Meeting Notes

Project: I-70 Floyd Hill to VMT
Meeting: ALIVE Meeting #5
Date: February 26, 2020, 9:00am-12:00pm
Location: CDOT Region 1, 425A Corporate Circle, Golden, CO, Lookout Mountain Room

Floyd Hill - ALIVE ITF Meeting #5 Notes
February 26, 2020, 9 AM to 12 PM
CDOT Golden - Lookout Mountain Conference Room

Mitigation Option B

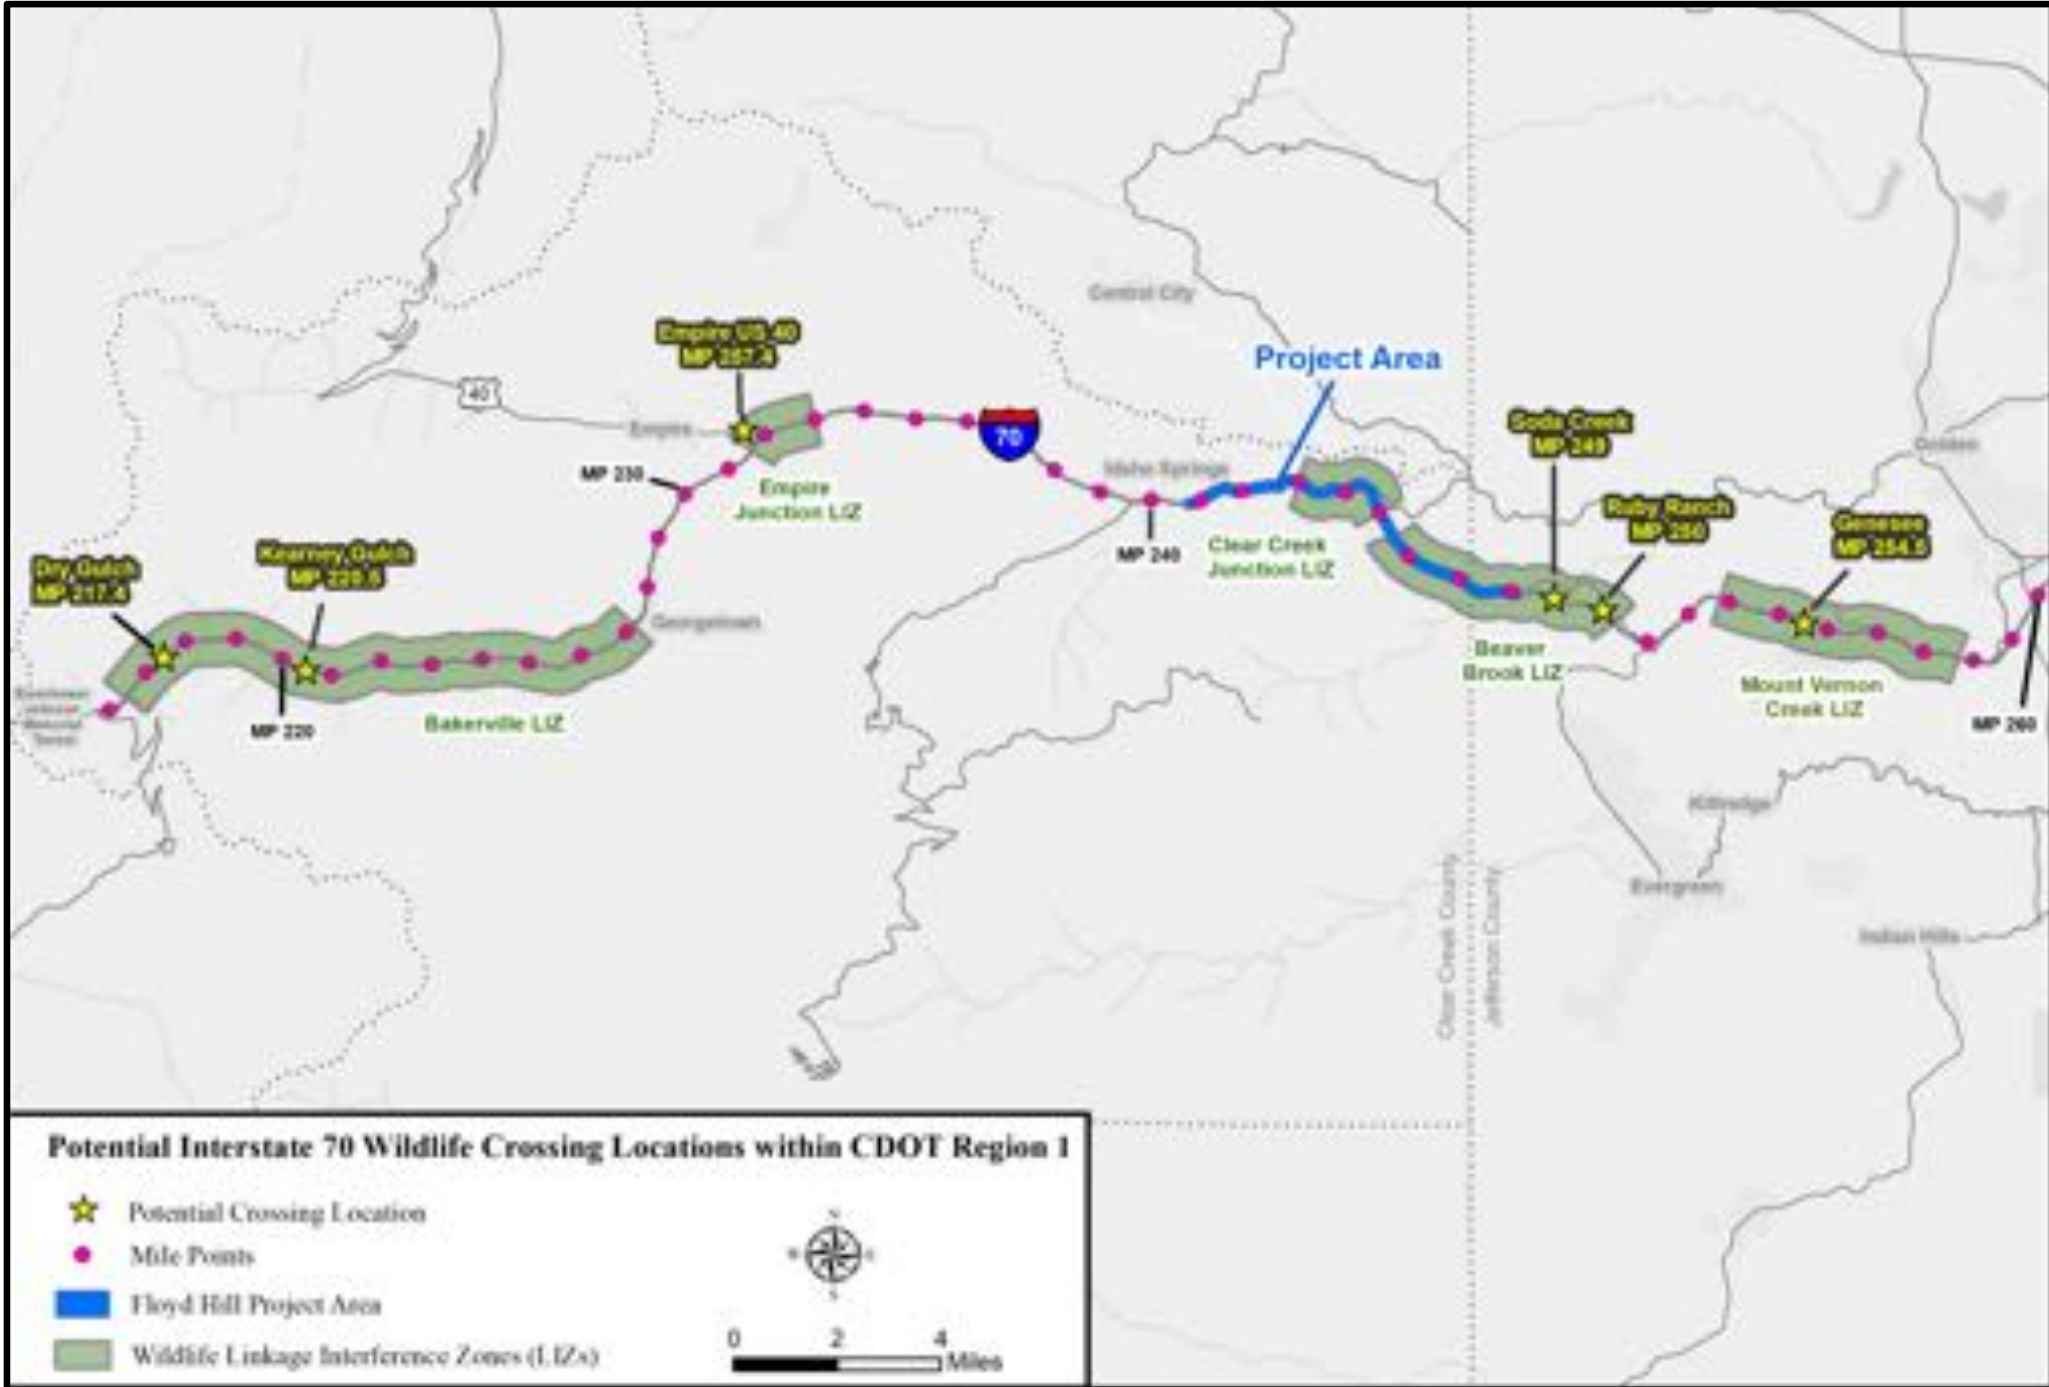
1. Select alternative location(s) for wildlife crossings mitigation on I-70 in Region 1
2. Fencing to reduce WVC at the top of Floyd Hill

MP 249 – Soda Creek

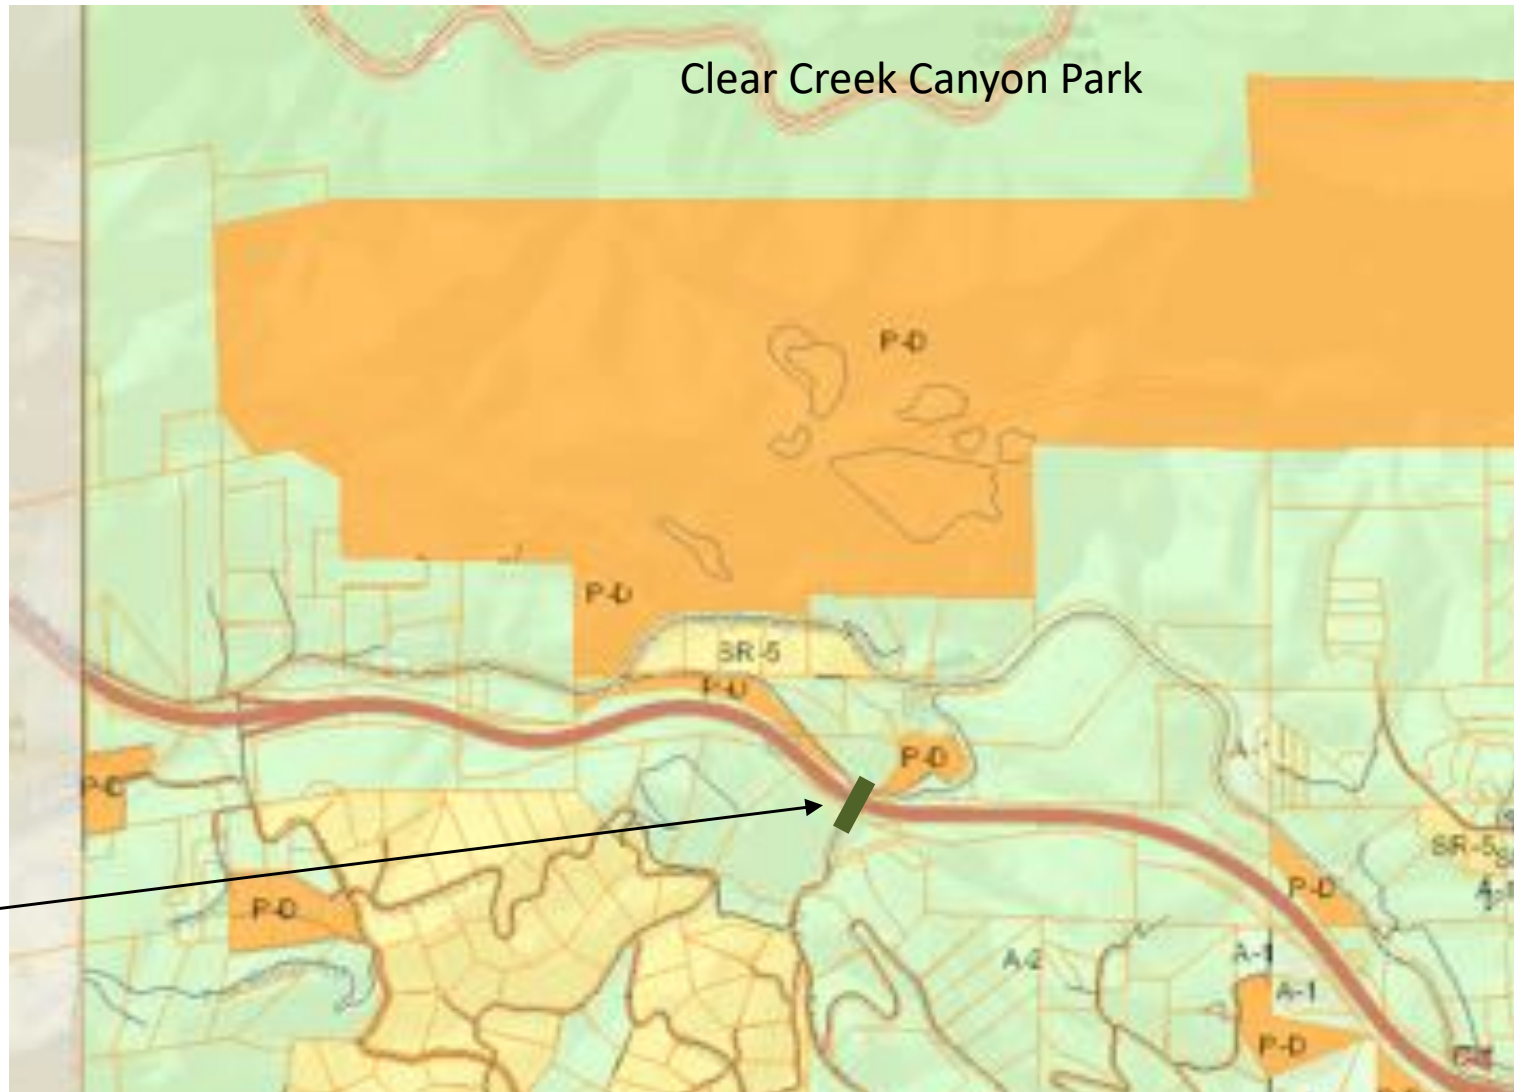
- Existing bridge is 137' wide; dirt road with riprap slopes
- Residence in front of south entrance

Would replacing this bridge with a larger structure appreciably increase wildlife passage under I-70?
